From: KEN T ATWELL <[kenatwell@bendbroadband.com](mailto:kenatwell@bendbroadband.com)>  
Sent: Wednesday, November 14, 2018 2:30 PM  
To: Karen Swirsky <[kswirsky@bendoregon.gov](mailto:kswirsky@bendoregon.gov)>  
Subject: Add tom CTAC meeting record

From: Ken Atwell, SE Bend resident

RE: US 97 Parkway Plan and Bend CTAC Scenarios

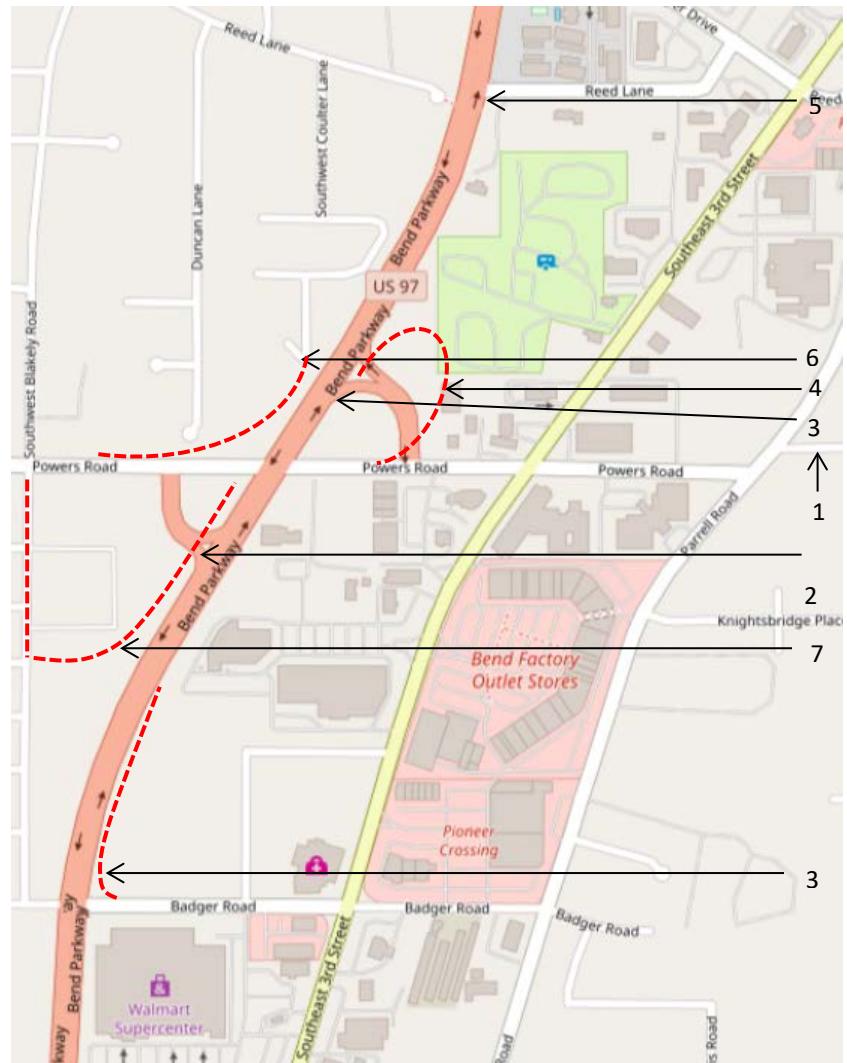
First, the only way to attract traffic bound for housing on Brosterhouse to Powers Rd. is to extend Chase to Brosterhouse (see map on page 2). Without this Powers east, ending at Parrell, either leads back to the Reed Market/Third Street traffic or Murphy which many might consider to be the long route.

Second, the access ramp to 97s from Powers, with its left turn access from the east and its nonexistent acceleration lane, should be eliminated since any anyone using it just came from Third Street or Brookswood where a multimillion dollar on-ramp was just a mile farther south. Any attempt to extend this 97s on-ramp to an appropriate length for Powers east traffic would preclude a 97s off-ramp and holding lane of appropriate length (item 7 on map) for Powers east using Blakely as a return to Powers.

Third, replace the same access design as above used for the ramp to 97n from Powers by providing that 97n access with acceleration lane from Badger. Just a short trip around the block then provides, with modest ROW purchase, the safe 960 foot acceleration lane that ODOT prefers. At the same time of course the 97n right turn off option at Badger would be eliminated. This would also allow closure of Pinebrook because those seeking 97n access have it a block away and those seeking safe Third Street access from 97n ignored it only three quarter of a mile earlier. With proper development control of the one block of Badger prior to this on-ramp there would be the potential for a two 450 foot lanes for holding and metering access to 97n. Despite the fact that using this access involves dealing with a stoplight, it could replace the planned, and possibly more expensive, 97n access planned south of the Murphy/Third circle.

Fourth, with a future Powers overpass in mind and the 97n access now eliminated from Powers west, full use of the available ODOT ROW here allows a 900 foot off-ramp from 97n starting immediately after crossing Powers. This would be for access to Powers west only, again eliminating the dangerous cross traffic option of exiting to Powers east.

Fifth, with the 97n access from Powers now eliminated, the Reed Lane 600 foot off-ramp ROW becomes an option for 97n traffic to exit to Third Street and Powers west which is again just around the block. This would require Reed Lane to become one way east and take advantage of an existing four-way stoplight at Third Street while still providing the required "second way out" for the apartment complex to the north. This could possibly replace the 97n off-ramp at Reed Market east with its cross-traffic left turn option and traffic slowed by the one block available to negotiate a left turn onto Third Street.

Sixth, some of the traffic that now waits on 97s to turn onto Powers west could be contained in a deceleration lane constructed on the existing ODOT ROW. An even more effective turn lane would include the ROW purchase of the three properties located east of Blakely and currently accessed from Powers west. This ROW purchase would eventually be required for an overpass to cure the real safety problem here which is the stoplight, so now may be as good a time as any. While another option would be to use the ODOT ROW at Reed on 97s to access Blakely north of Powers, this would be very disruptive to a developed neighborhood.

Seventh, while there is existing ODOT ROW at Badger from 97s, using this to access Blakely for a return to Powers east would result in three sources of backup - a deceleration lane of only 300 feet with existing ROW, a sharp turn onto Blakely where homes access to/from that street, and traffic using a narrow Badger Rd. with on-street parking to access homes and Brookswood. With the purchase of property at 61308 Blakely and possibly two other minor property line adjustments, Powers east could be accessed with a 1,000 foot decel./holding lane and only three access driveways disrupting flow on Blakely. This would also allow access to Badger and the homes there so that the right-turn only access to/from 97s could be closed.

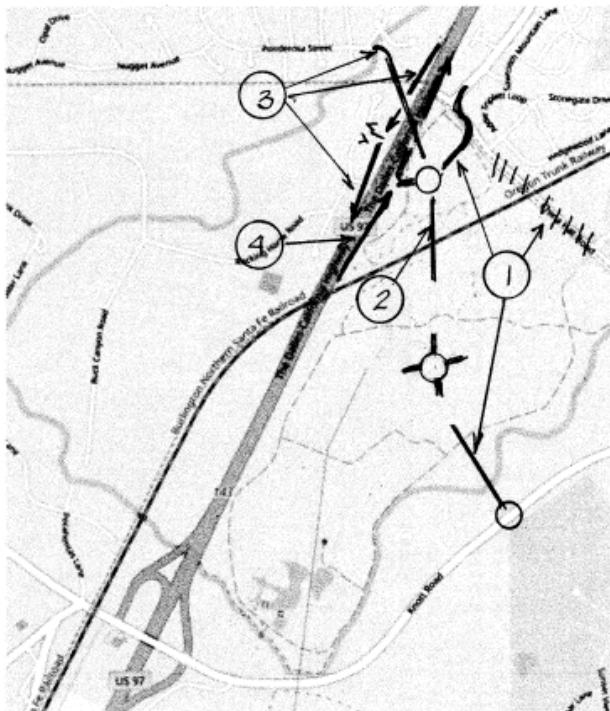
1. Given the rock that will be encountered at the proposed 97n access site adjacent to the Third Street on-ramp to 97s, would the Badger access to 97n proposed above provide a more cost effective location?

2. If the 97s access to Powers east suggested above were accepted would the long frontage road often suggested from Badger to Murphy west be needed? Instead, could the Murphy west off-ramp start after Pinebrook, rather than the frontage from Badger, and extend 800 feet to Murphy west with a local road intersecting before it reaches Murphy for a connection to and that development's required second way out and thus close the right turn only access at Pinebrook?

4. The Murphy Crossing Refinement Plan (2007) indicates a traffic circle at the west terminus of the Murphy/97 overpass and south terminus of the access road described above. Considering the Murphy Interchange as built it appears to have insufficient ROW for this circle which may have been designed as the access point to Murphy east. However, both the above study and the Murphy Interchange IAMP (2007) show a 97s off-ramp immediately south of the overpass as the start of both a road returning to Murphy at a traffic circle and a frontage road extending south to Ponderosa. This presents two options for delaying investment. The circle planned west of the overpass for access to Murphy Crossing could be used as a return to Murphy east for traffic on Murphy west that used the 97s exit at Pinebrook, or the 97s exit planned south of the overpass could be constructed for a road returning to Murphy east and the traffic circle delayed. This decision could hinge on how urgent the need is to correct the China Hat, Ponderosa, and Baker Road access issues.

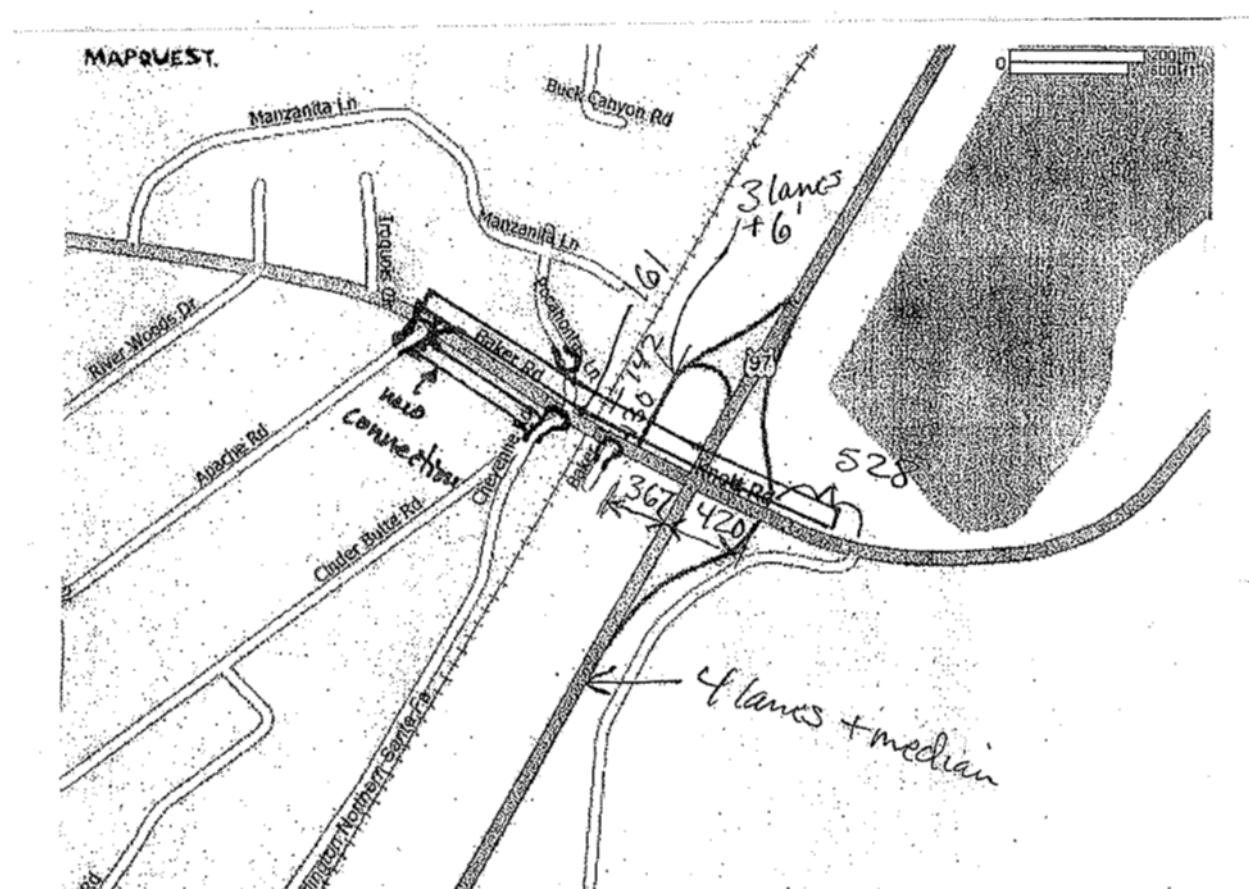
**RATIONALE:** Baker Rd intersects US97 approximately 600 feet to the east of the RR and is carried over US97 on a structure. The profile of this bridge will not match the needed profile over RR, therefore the bridge must be replaced. Assume the new overcrossing would be adjacent and to the north of the existing one. There are on/off ramps to US 97 that will need to be raised to match the profile of the overcrossing. There are approach streets to Baker Rd on the west side, which also must be raised to meet the new profile, rerouted or access stopped with a cul de sac.

With this approach the stopped and crossing right and left turn issues are not addressed, and the potential for Hwy. 97 off-ramp backup persists.
